STATE OF NORTH CAROLINA  
DEPARTMENT OF TRANSPORTATION

Subject: **Application for Modification to Section 404 Individual Permit, Section 401 Water Quality Certification and Tar-Pamlico Riparian Buffer Certification:**  
Western Outer Loop from SR 1128 (Ruin Creek Road) to SR 1101 (Old County Home Road) near Henderson (Vance County), Division 5.  
Federal Aid Project No: STP-0509 (2), State Project No: 8.2390201,  
TIP No: U-2527, \$475.00 Debit WBS Element 34822.1.1

Reference: USACE Action ID: 199708127  
NCDENR-DWQ Project No: 031494

The purpose of this submittal is to request a modification to the Section 404 Individual Permit issued by USACE and the Section 401 Water Quality and Tar-Pamlico Riparian Buffer Certifications issued by NCDENR-DWQ for changes to stream and buffer impacts. Revised permit drawings are attached. Please note that these revised drawings also depict changes to the project design such as the addition of rip rap in areas that will not impact streams, wetlands, or buffers.

SHEET 23 OF 41 Rev. 08/08/06

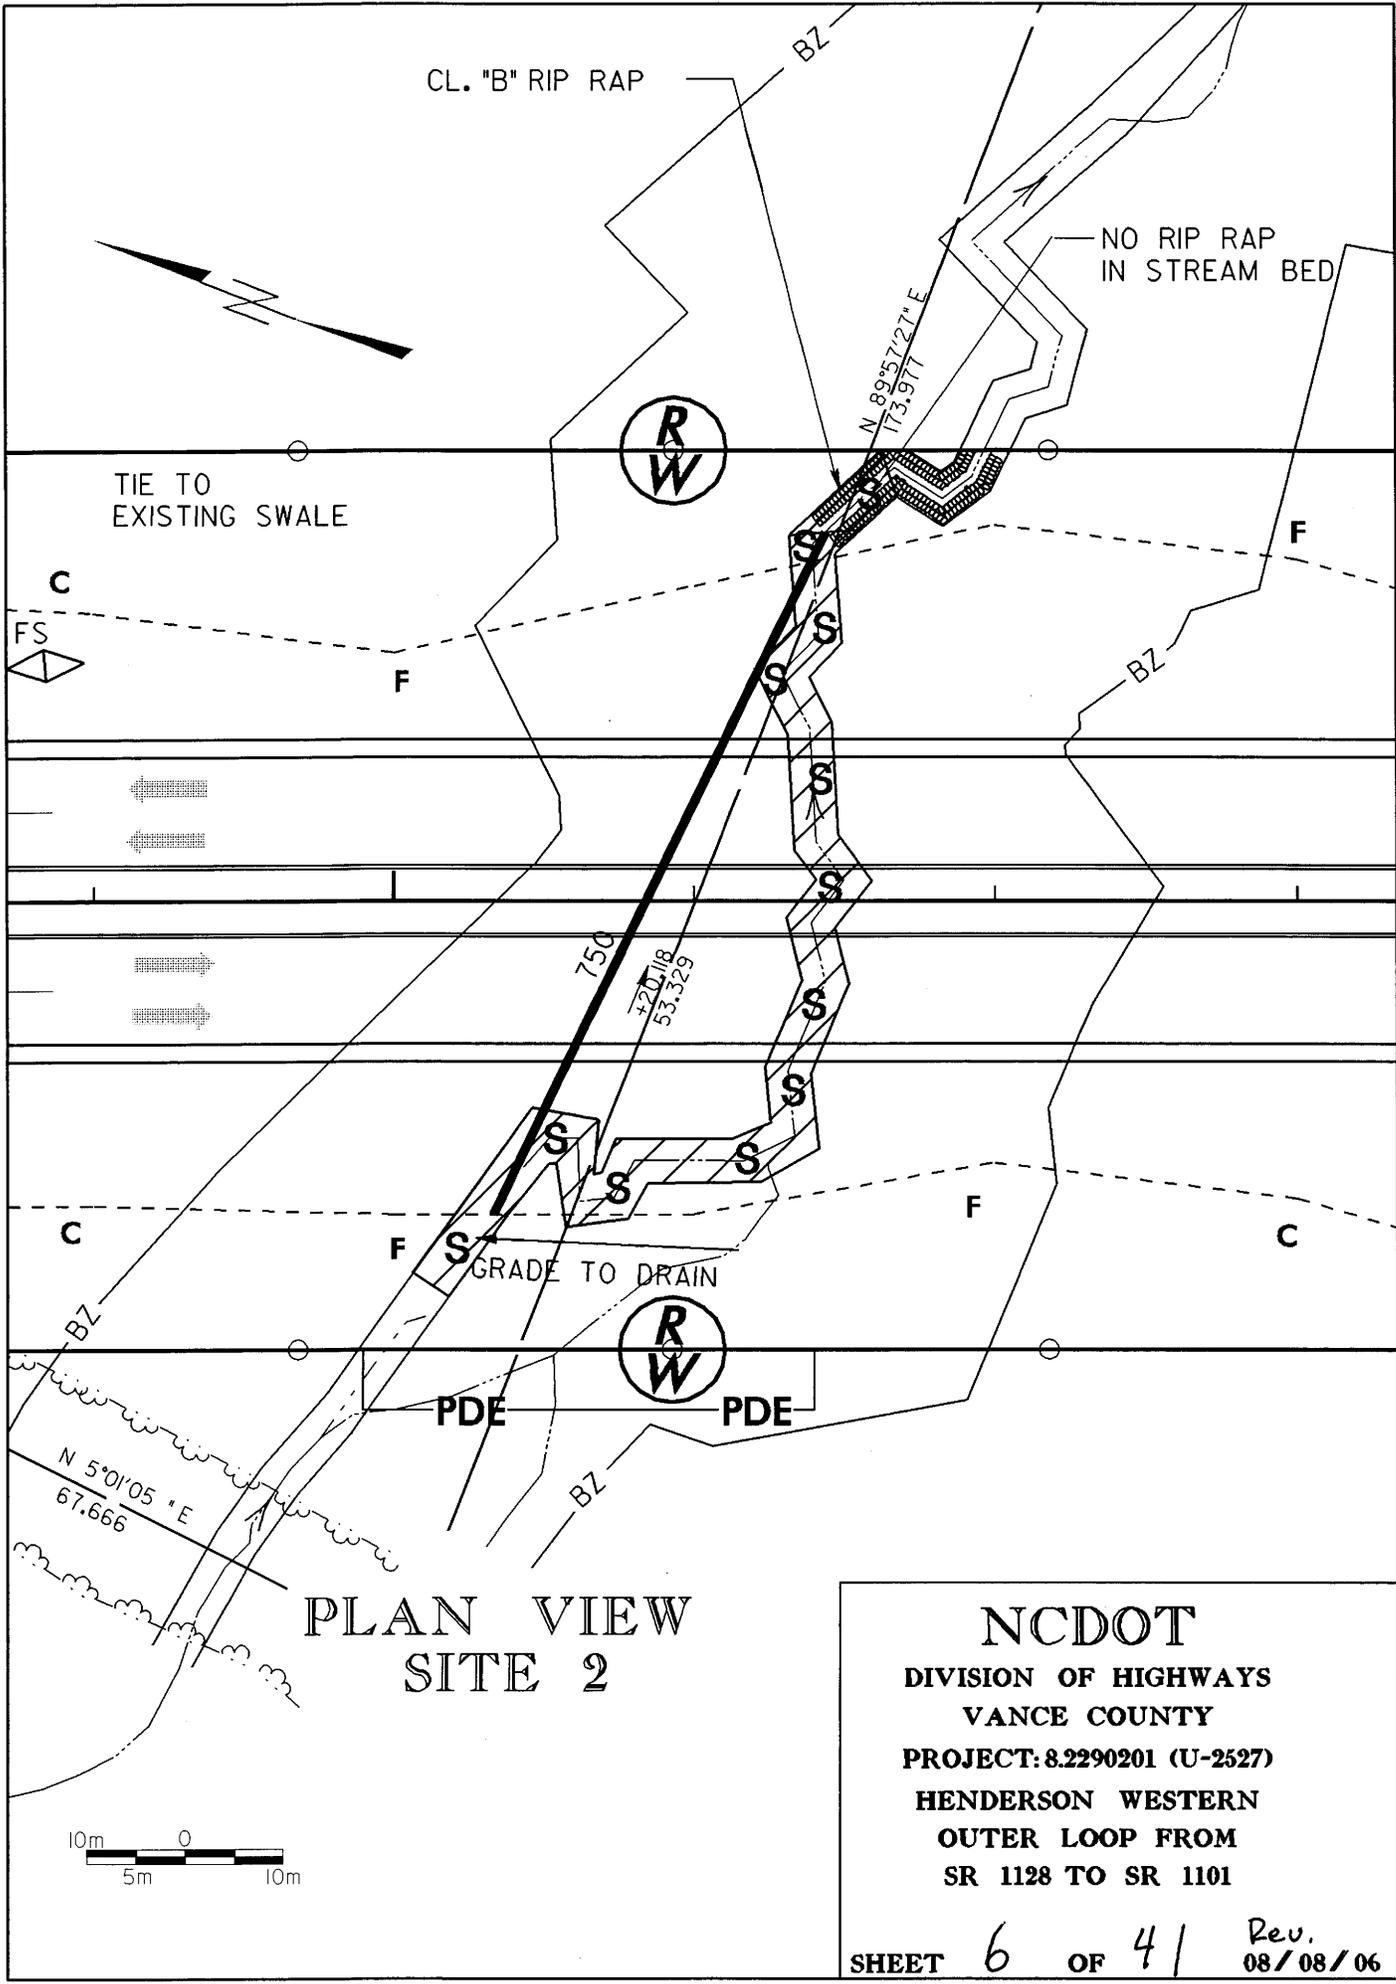
### Permit Drawings 6 and 23 of 41/ Site 2 (Revised August 2006)

-The streambank at the outlet of the structure has become unstable within the Department right-of-way. This may be attributable to the angle of the structure at the outlet in relation to the stream.

-The Department proposes to add additional rip rap along the streambank from the outlet of the structure to the right-of-way limits, which will provide long-term stability to the system.

**\*\*This will result in the following additional impacts: 46 linear feet of surface water and 1,184 square feet of riparian buffer Zone 1.**

PROJECT REFERENCE NO. U-2527	SHEET NO. 14
	R/W SHEET NO.	
ROADWAY DESIGN ENGINEER	HYDRAULICS ENGINEER

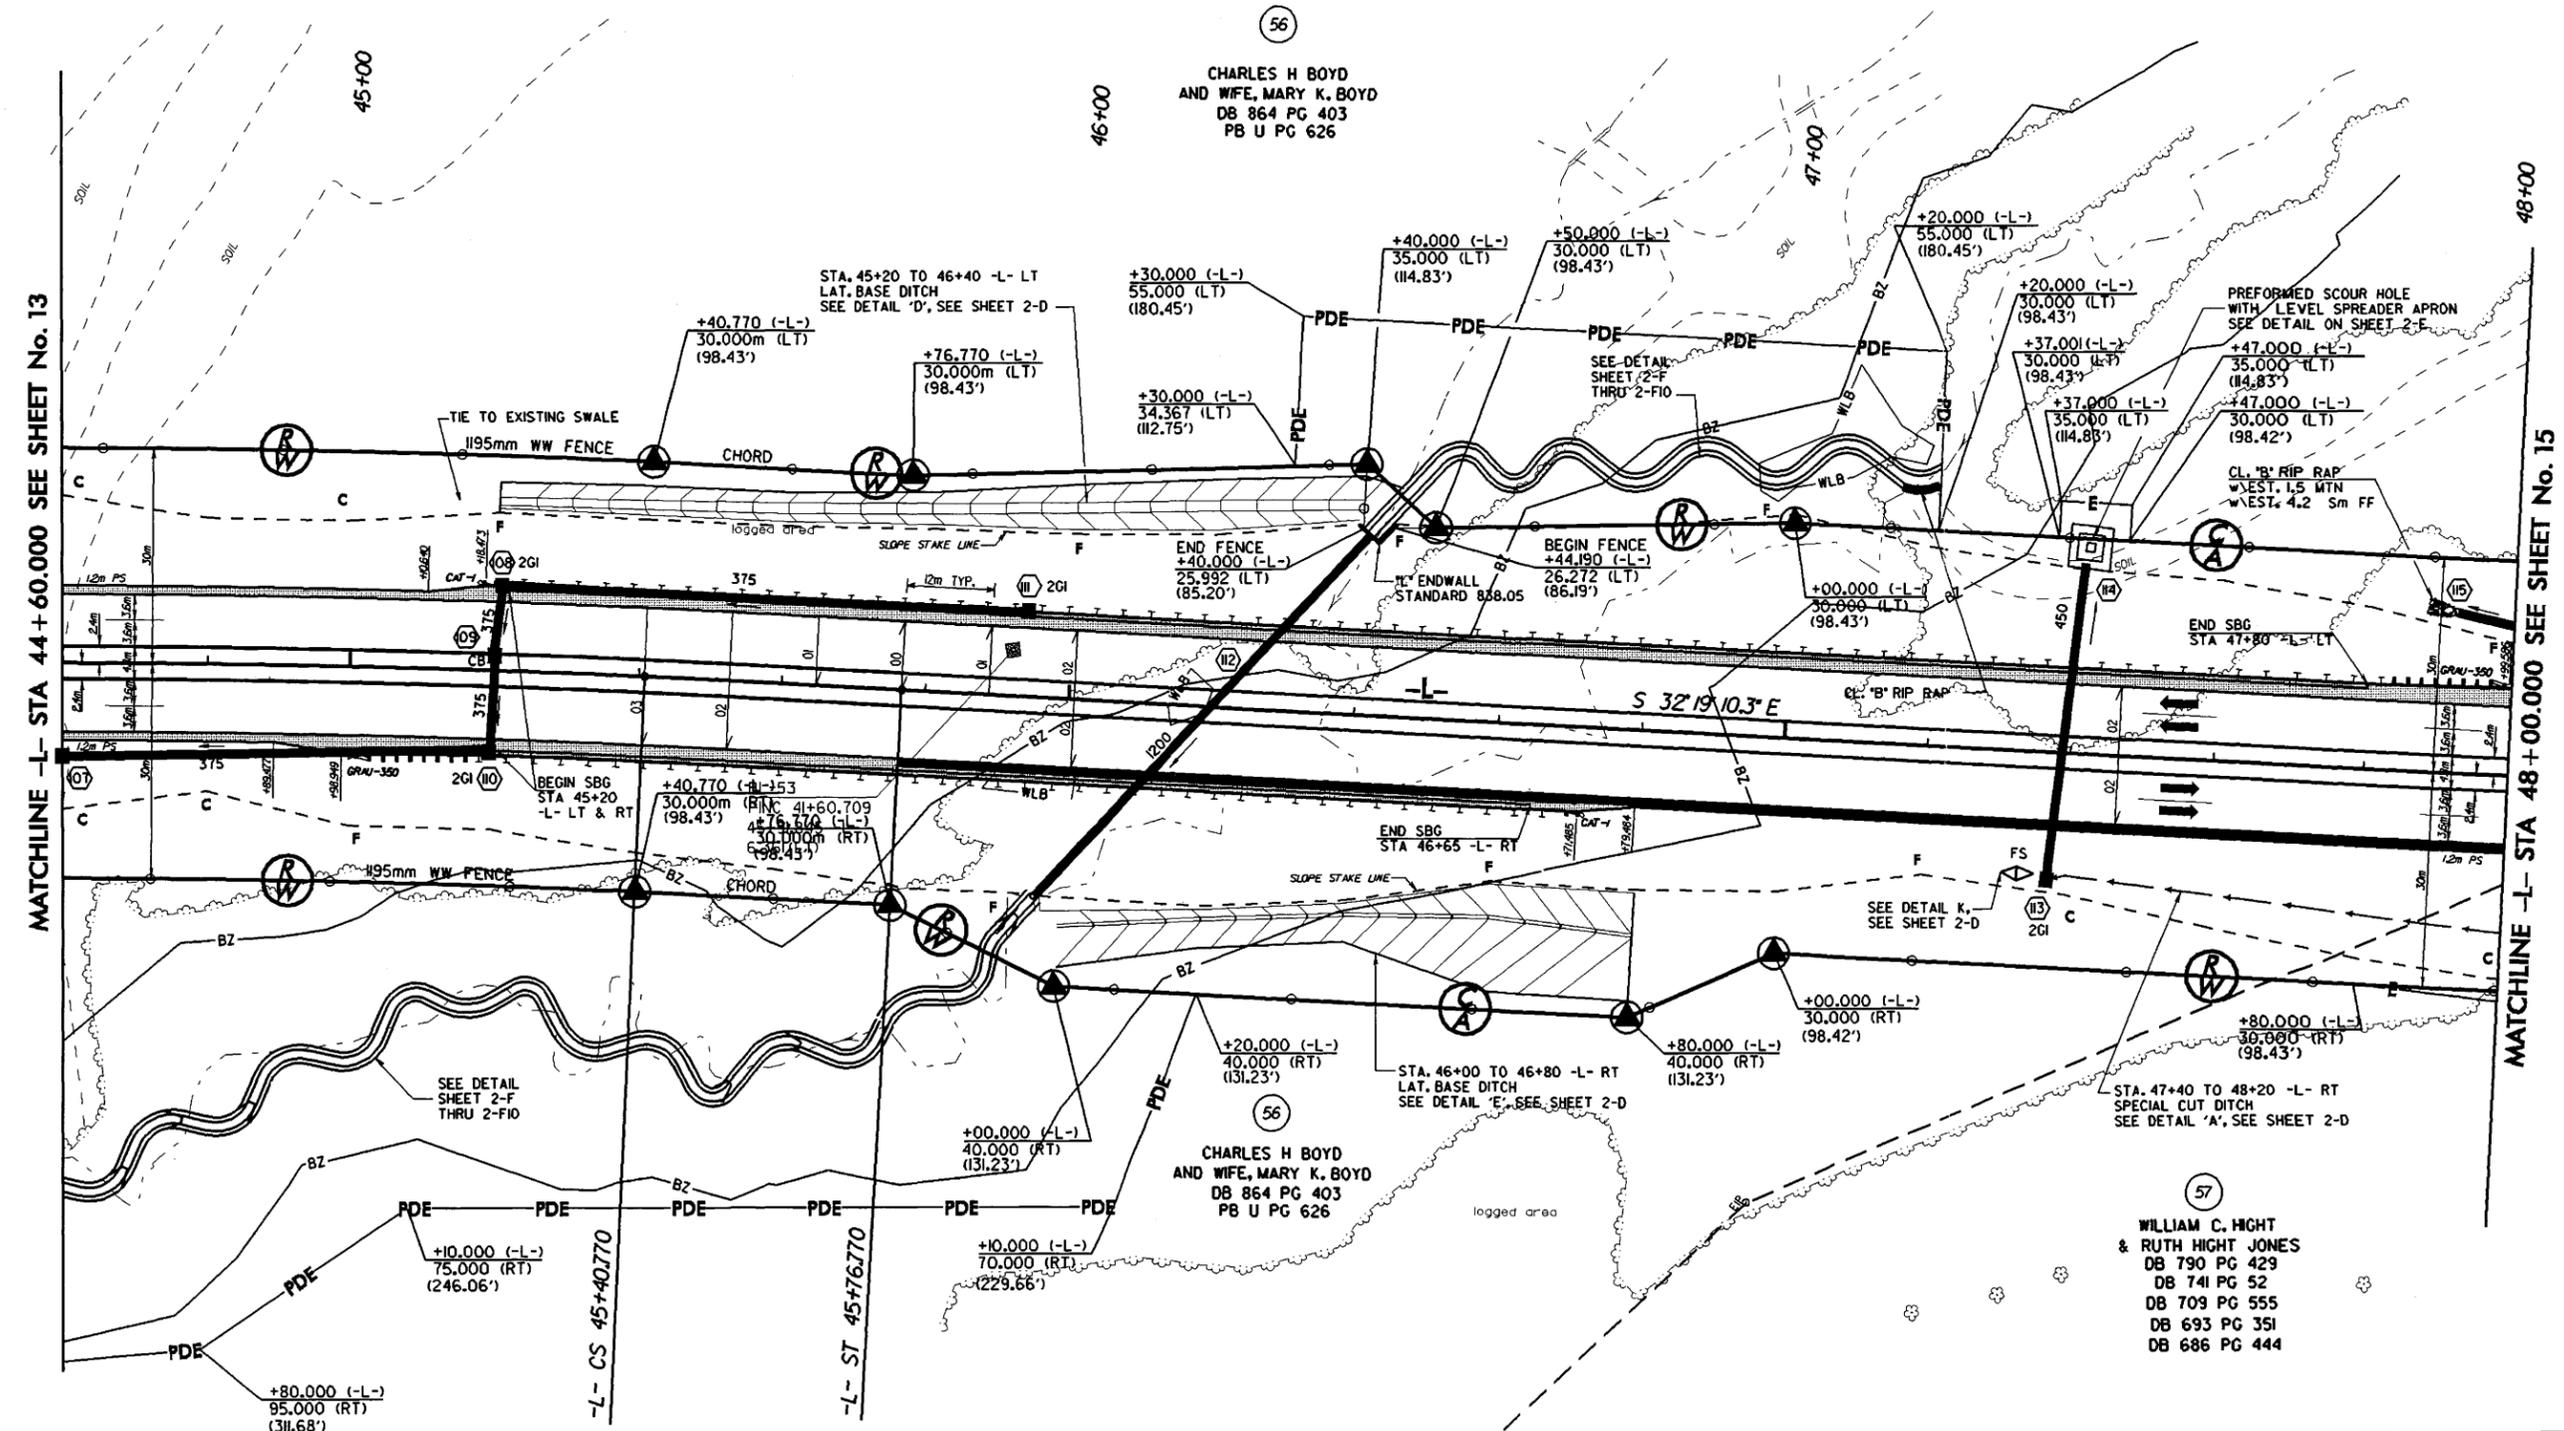
### Stream Relocation Plan Sheet 14 (Revised August 2006)

-The Department proposes to install approximately 20 linear feet of rip rap along the cut section in the floodplain adjacent to the relocated channel.

-This will prevent scour in the floodplain and provide long-term stability to the system.

-The rip rap will not be installed within the bed of the relocated channel or along the banks of the relocated channel.

**\*\*No additional impacts to streams, wetlands or riparian buffers will occur as a result of this action.**
